# Rehabilitation of Caucasian Highways Azerbaijan, Georgia and Armenia

Construction of the Gasan Su Cay and Shemkir Cay bridges  
in Azerbaijan - Contract EUROPEAID/112944/C/W/AZ

## Supplementary Design Review Report

**Supplementary Design Review Report**

1. Actual dimension of pile field.

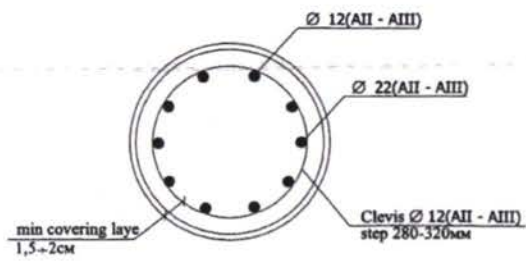
4. **Conclusions about opportunity of existing pile fields utilization for intermediate supports erection.**
  - 4.1. **Actual dimension of pile fields do not correspond to SNIP requirements 2.02.03-85 « Pile Reinforcement» , Clause 7.9 - clear distance between piles should be no less than 1,0 m, see Clause 1.**

**Conclusion: Given piles can't be utilized for bridge support erection.**
